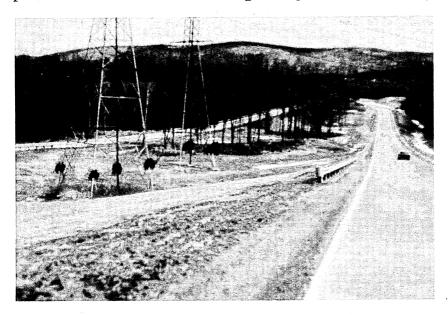
Here you see a guardrail supposed to keep cars from going into that river. It will not do the job. Somebody could go right through there and drown. Those trees won't do the job either; they're too small.

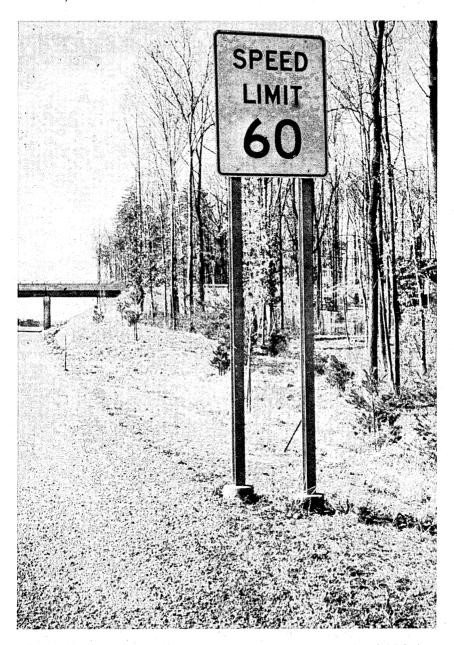
This is a speed sign, which you will find on the Maryland side of the beltway. Again the sign is mounted on two 4-inch I-beams embedded in 3 feet, 6 inches of concrete.

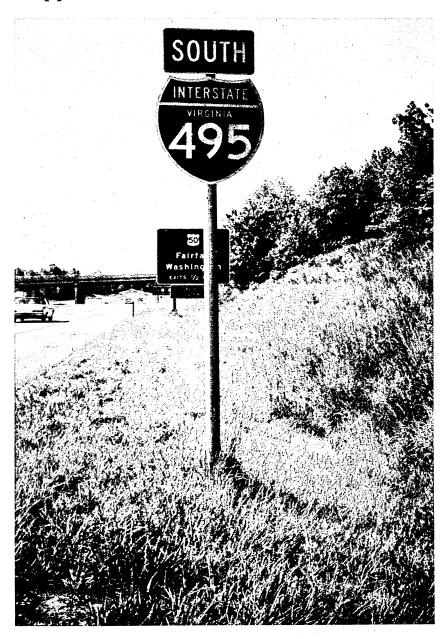
Now we go over to the Virginia side of the beltway. This is a route marker used all along the Virginia portion of the Capital Beltway. Again, a couple feet off the shoulder area mounted on a 4- to 6-inch steel pipe embedded in concrete.

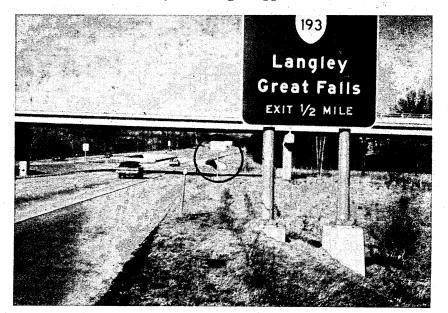
And here we have a concrete drain (indicating). Now the staff has seen photographs and the results of what has happened to a vehicle

which has gone down this drain. It could lead you right into this sign

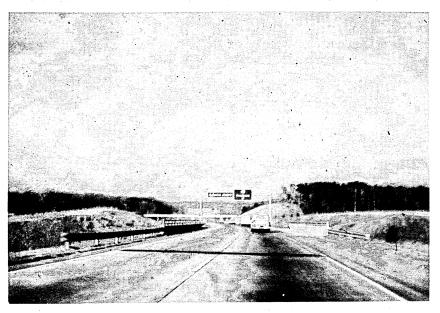
We can go to Virginia and we can find similar situations. Here you have a guardrail approaching a bridge. Here is a guardrail not flared back on the left. The guardrail runs up to the bridge parapet. It is not anchored. On this side the guardrail extends back somewhat like an arrow. It ends at the bridge parapet. In this case they have taken the shoulder through the bridge.

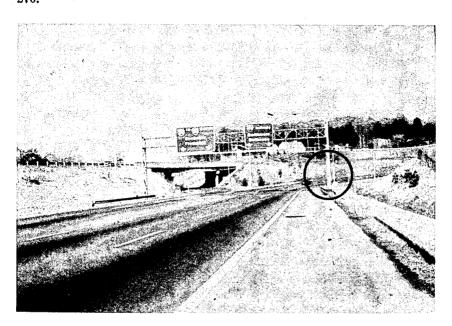
This is the light pole in question, where the arrow is pointing. And you will notice the reason why it has not been hit. There is a huge piece of concrete just in front of that light pole. The reason

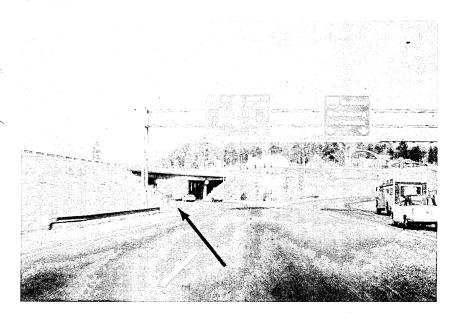
You will notice the concrete on the left side of the road (arrow). Before, I talked about a light pole which is to the right of this truck and there was a piece of concrete in front of the light pole. And I wondered why that was there. And I looked at them and I could not figure it out. I went to the State police and county police and I talked to them.

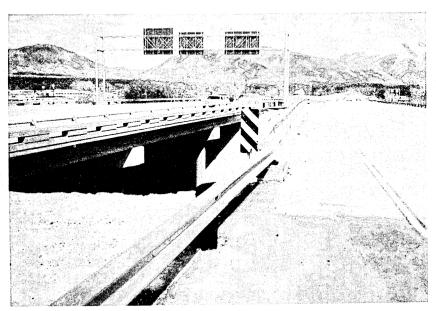
Mr. Zion. Mr. Prisk, in this last slide, the rail is not blocked out. It looks as though it is low enough that a wheel wouldn't go below the W-beam. Is that correct?

Mr.Prisk. That is right. This rail was about 25 inches, if I recall correctly, on this particular project; 25 inches was their mounting height. So you would—

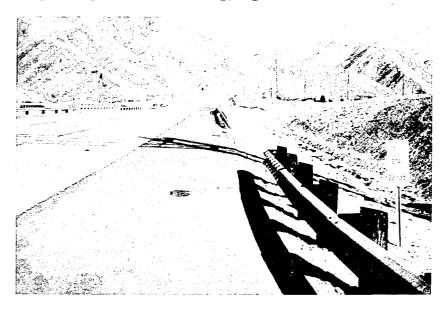
Here is a case of another gap where there is a rail discontinued here and picked up over here [indicating]. Again the same sort of situation.

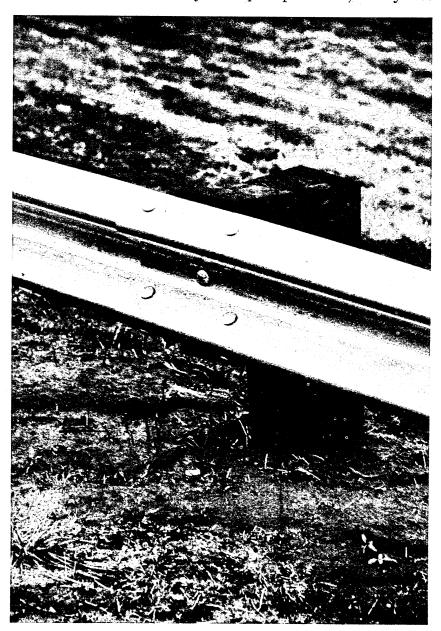
Here is the median barrier where there is an 8 by 8 post, rail bolted directly on, again without washers.

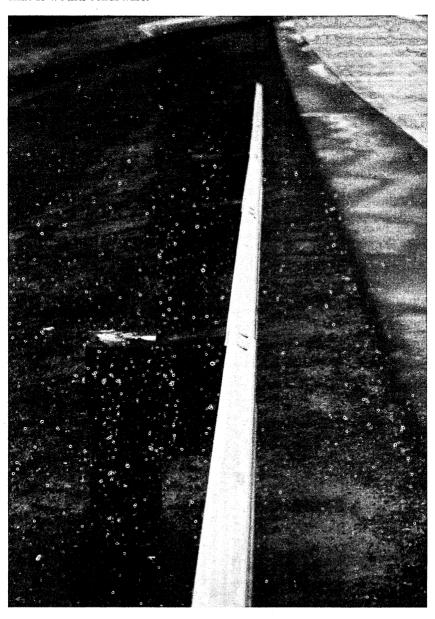
Here you do see that muddy area between the edge of the shoulder and the rail, makes you wonder a little bit whether that rail would perform as well as if it had a paved surface coming up to the face of it. When it is soft, certainly the wheel would be down somewhat lower that it would otherwise.

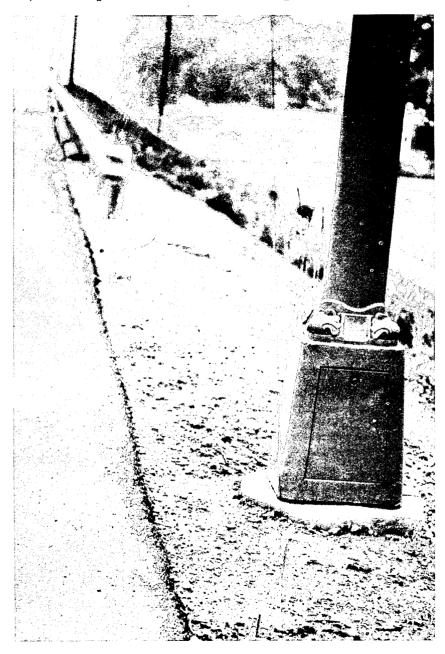
Mr. Constandy. In this we have a good picture of the slot where, incidentally, there is no washer. When the forces are applied to the guardrail, that slot can open and you can see how easily the bolt head

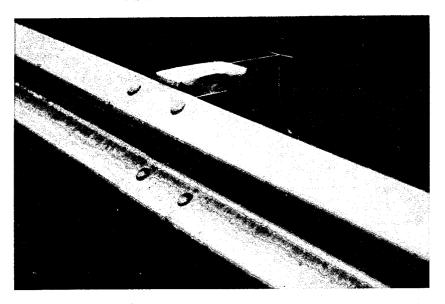
Mr. Skeels. That bridge rail appears to be extremely low.
